RE: Overshot Horizontal Flat Plate Fish Screen

Enclosure 1 - Operation, Siting, and Design Criteria¹

Subject: Farmers Screen, NRCS Programs and CIG Grant

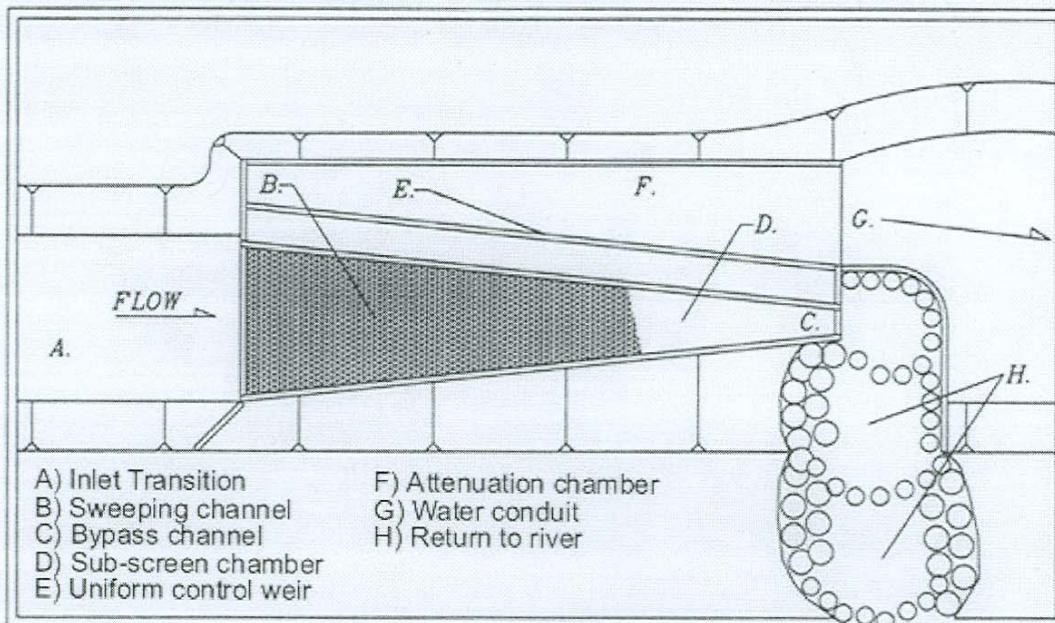
- **Normal velocity (V_N):** The velocity of flow throughout the entire plane of the screen (generally perpendicular to the plane of the screen), at any given point, should not exceed 0.25 ft/s after correcting for net open area (V_N in this case is the velocity through the open parts of the screen, or through-slot-velocity is V_N).
- **Sweeping velocity (V_S):** The water traveling parallel to the plane of the screen should have a sustained velocity throughout the entire length of the screen, averaging about 4 to 8 ft/sec in order to achieve the maximum cleaning dynamics and fish protection. A taper wall is usually required to maintain correct velocity parameters.

- **Depth of water over screen:** The depth of water over the entire screen area should be maintained at a uniform level between one and two feet. The actual depth will vary as a function of screen size and overall hydraulic conditions. A taper wall is usually required to maintain a uniform water surface elevation over the plane of the screen.
- **Screen area:** The total screen area must be large enough to achieve the correct V_N after correcting for net free area (calculated using through-slot-velocity).
- **Screen hole size:** Screen hole size, material, and open area should be in compliance with NMFS standards and allow for an appropriate footprint size and approach velocity.
- **Length to width ratio:** The length to width ratio must be correctly determined to avoid disruptive hydraulic conditions across the entire plane of the screen.

- A. Inlet transition (from canal to screen)
- B. Sweeping channel
- C. Bypass (output) channel
- D. Sub-screen chamber
- E. Uniform control weir
- F. Attenuation chamber
- G. Water conduit
- H. Return to river
